Port Credit West Village

Street Right of Ways: Response to City Comments

2018.11.02

For City of Mississauga, by
the West Village Partners

STREET C

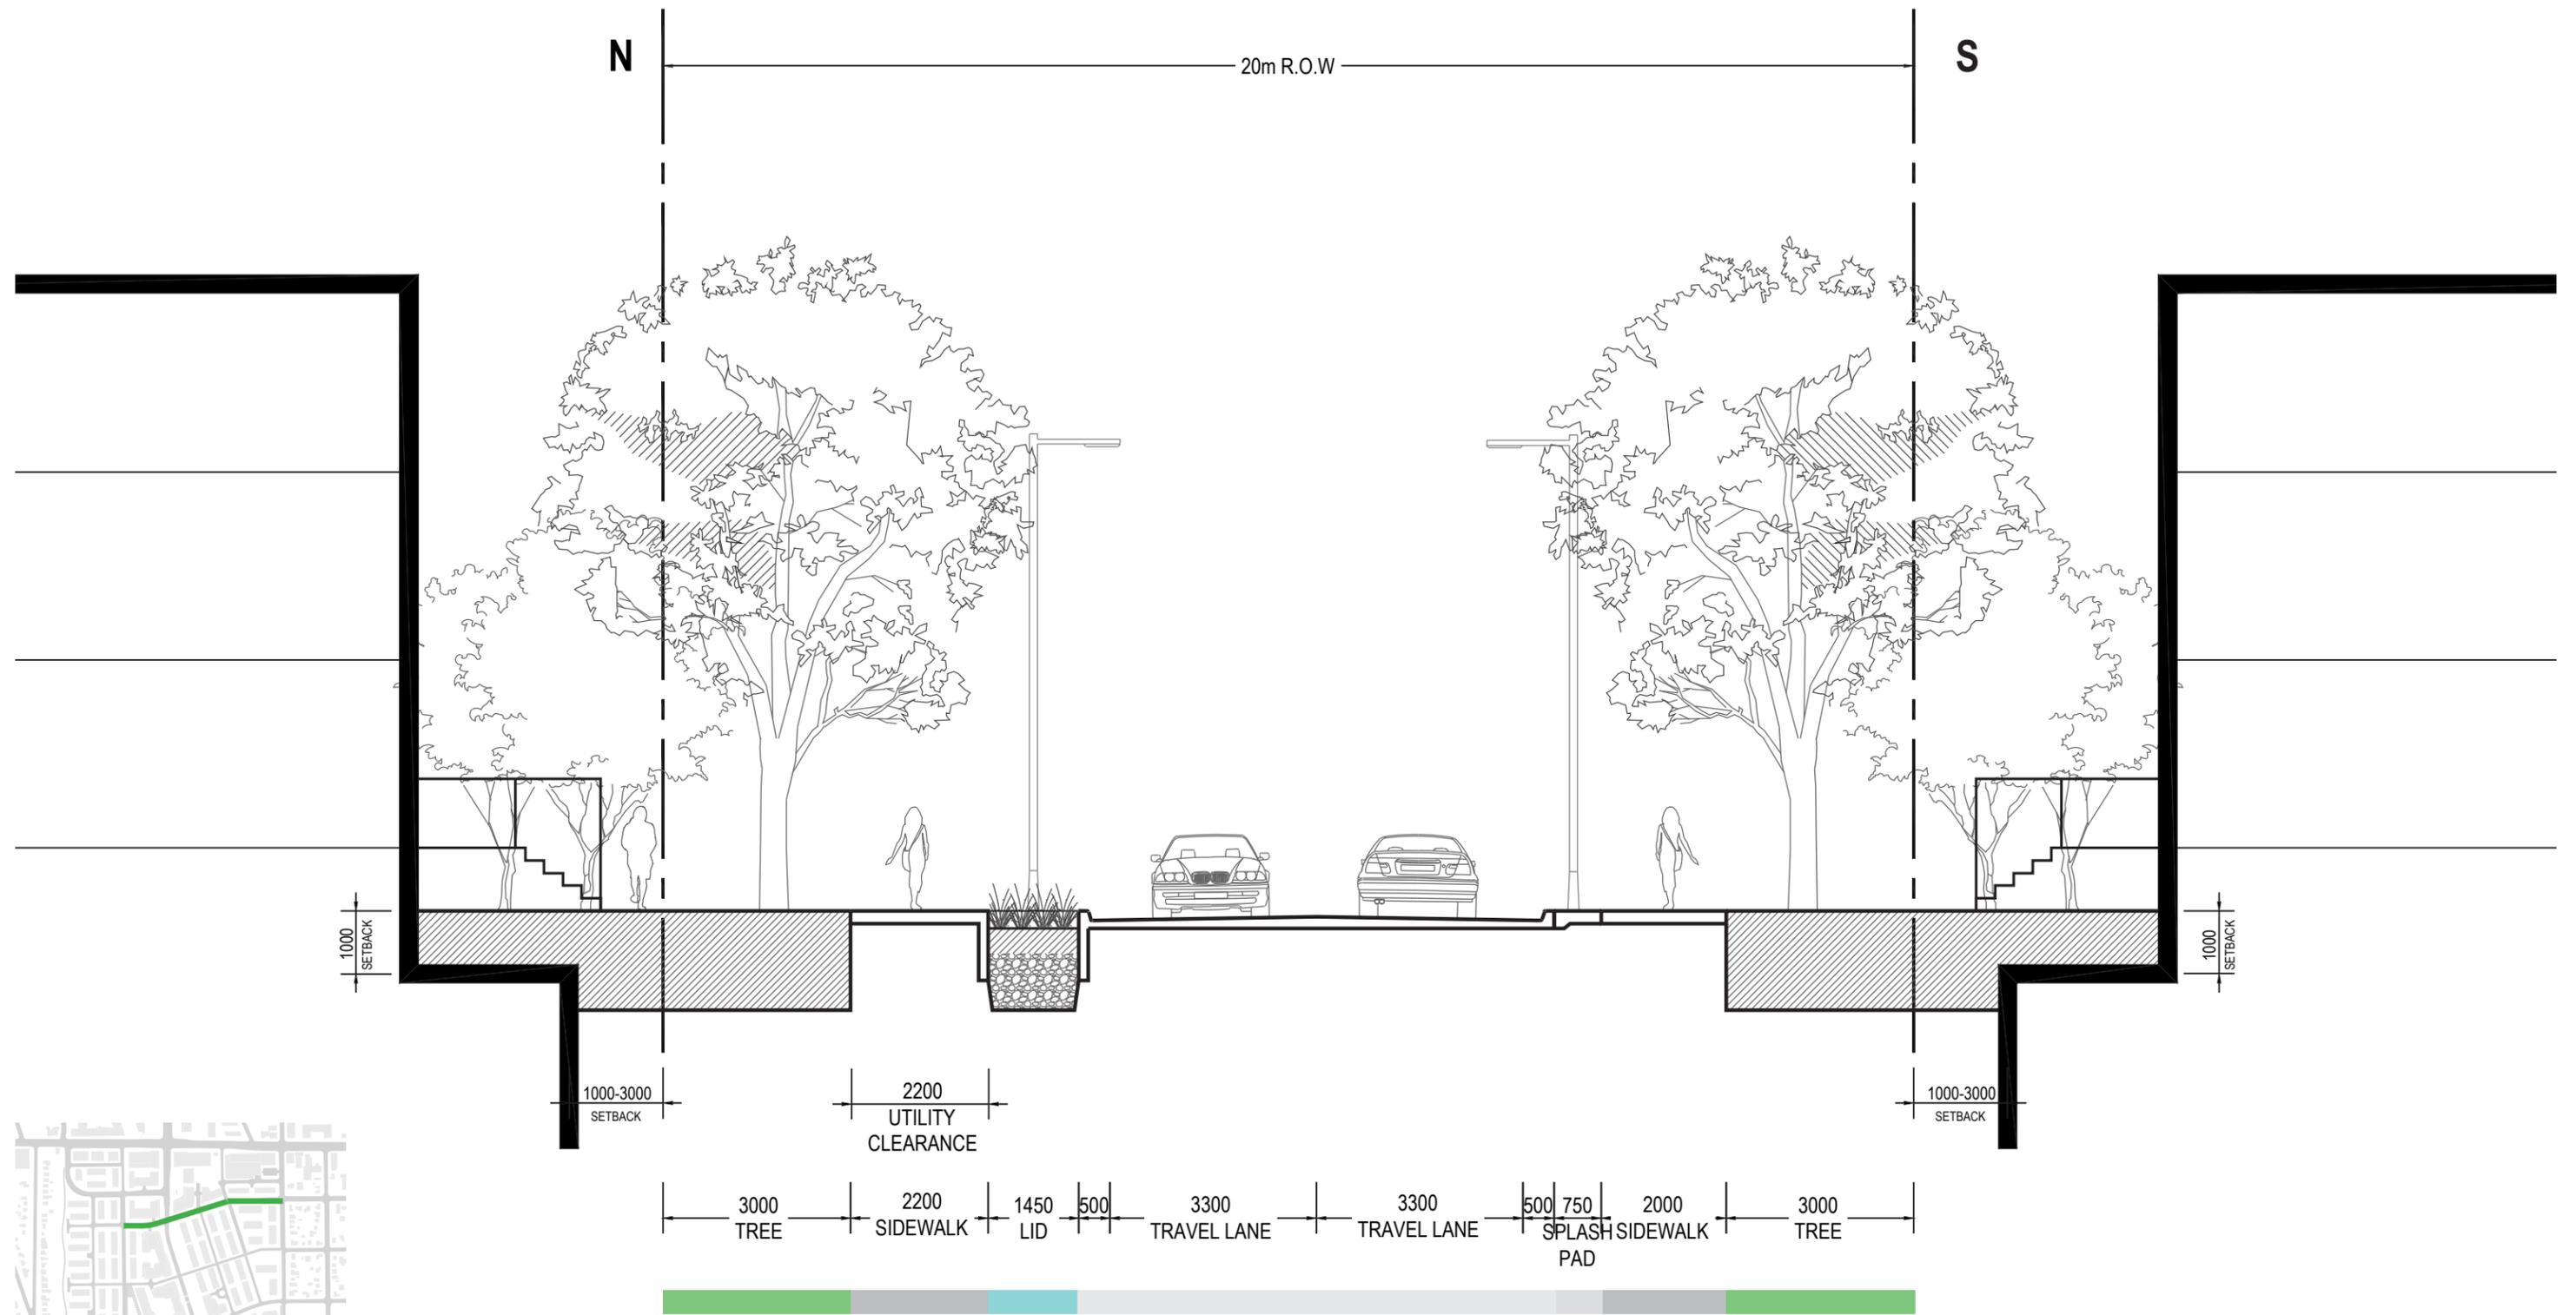
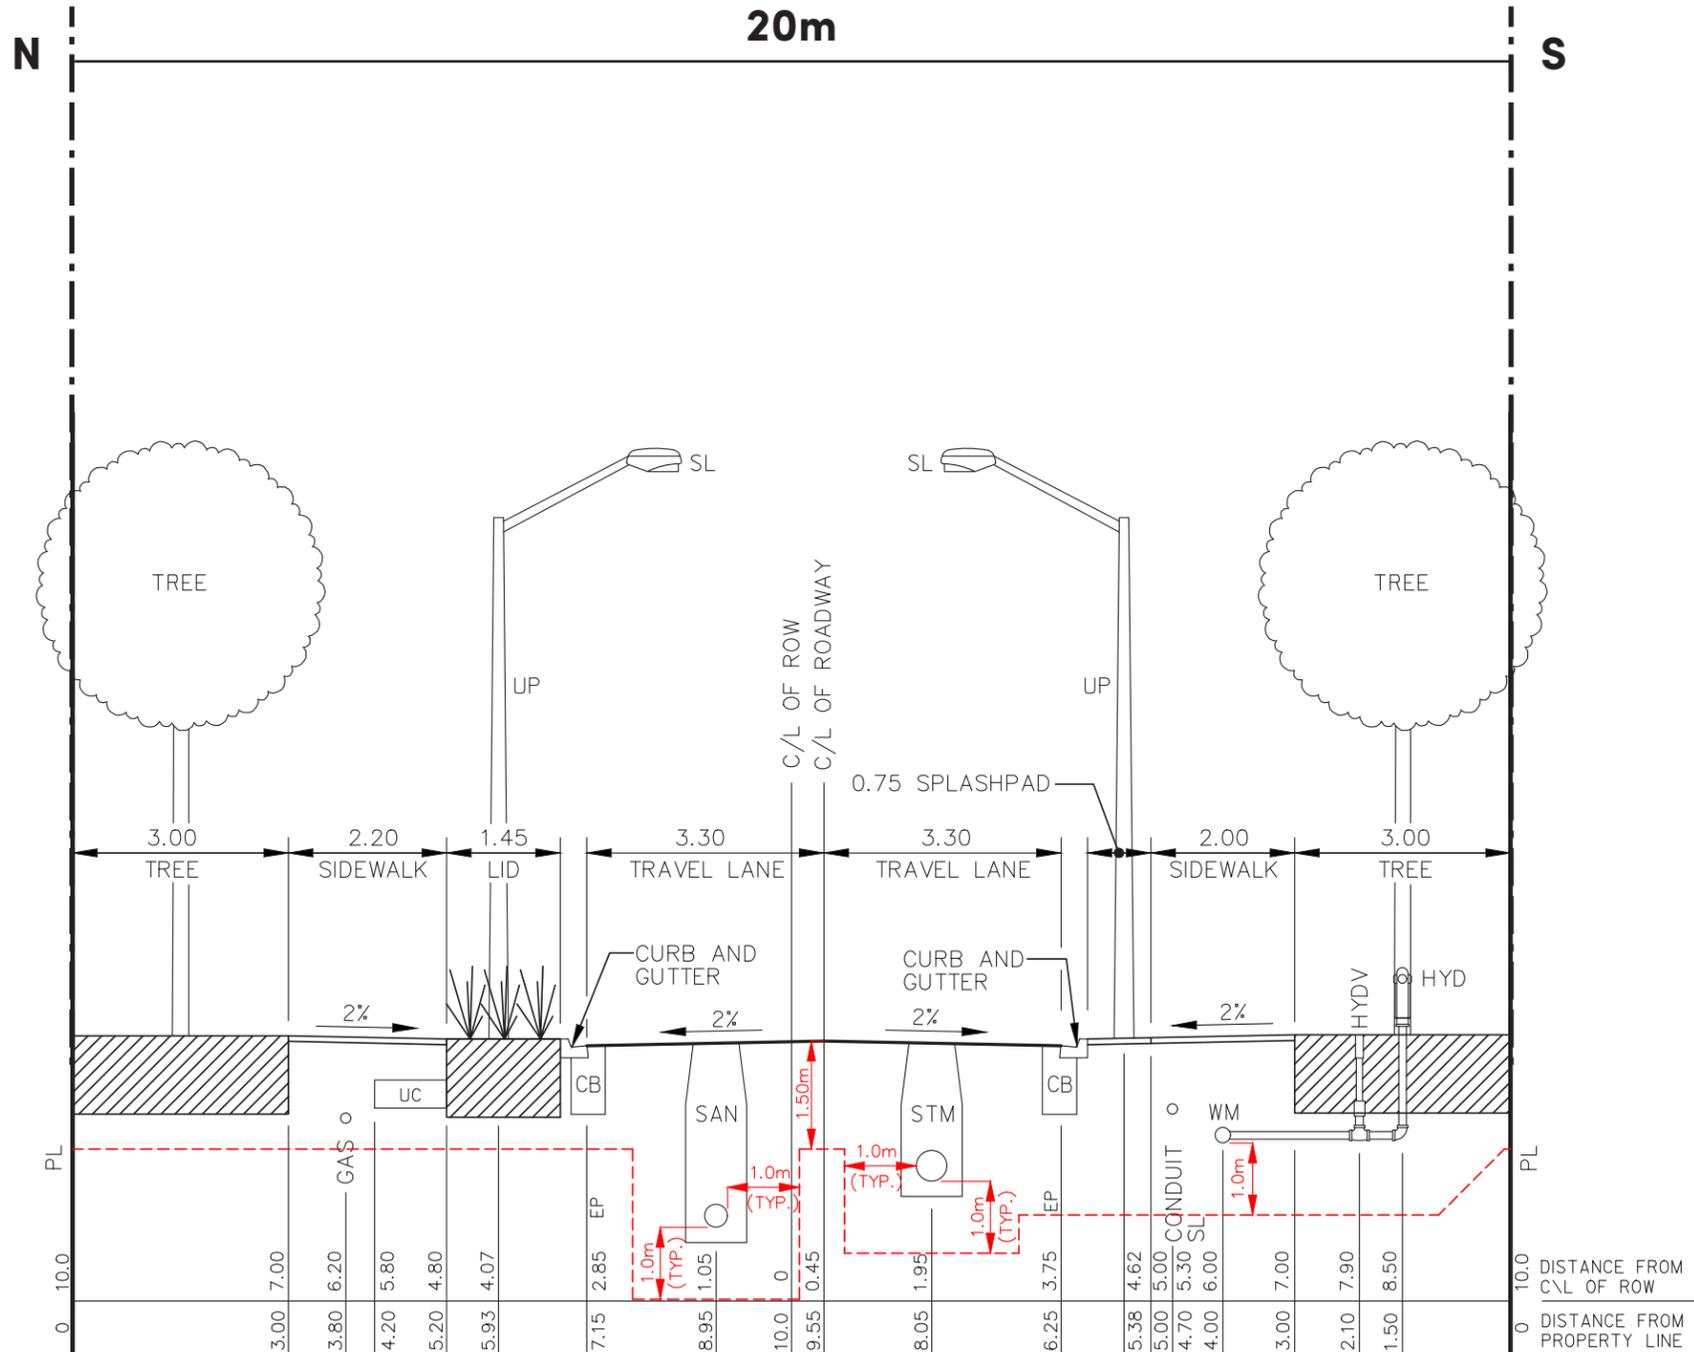
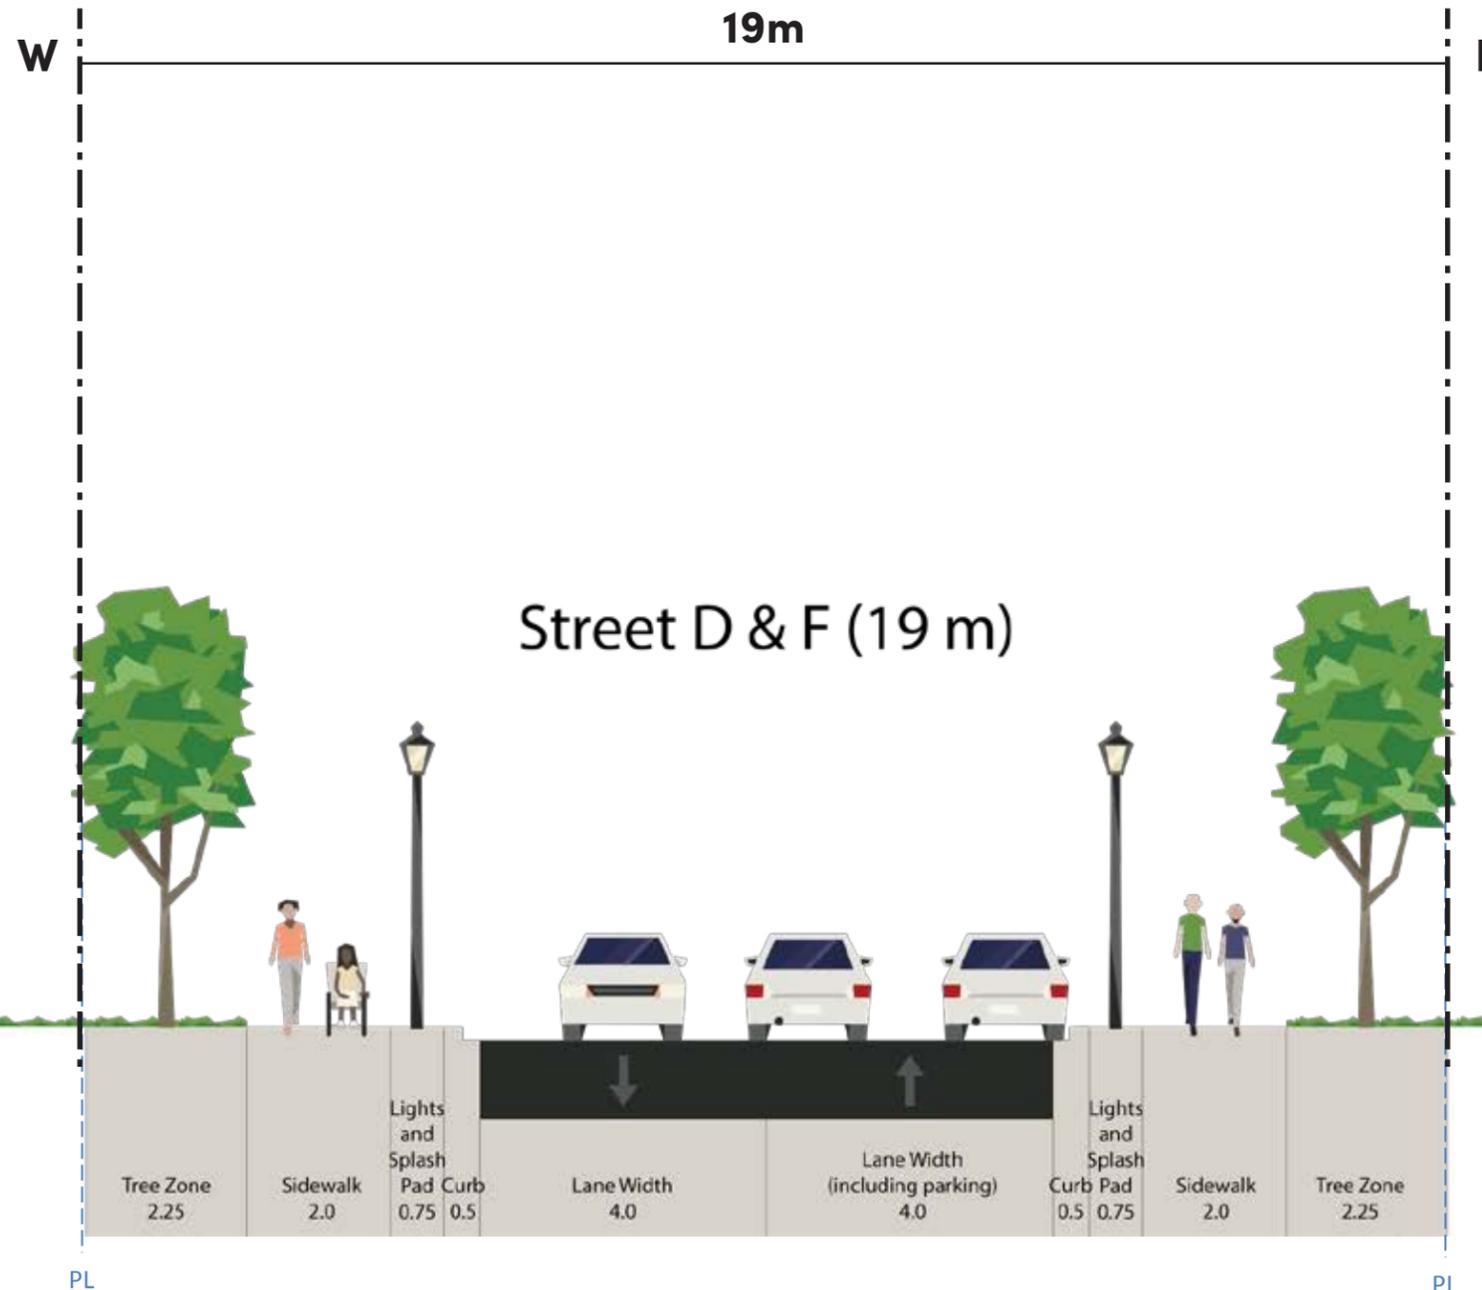
In line with City comments, cycling has been removed from Street 'C' and 'E'. We'll continue to accommodate it in the Mews - and in the now recently added private Street 'G' - for connectivity east-west between the Benson Trail and Mississauga Road.
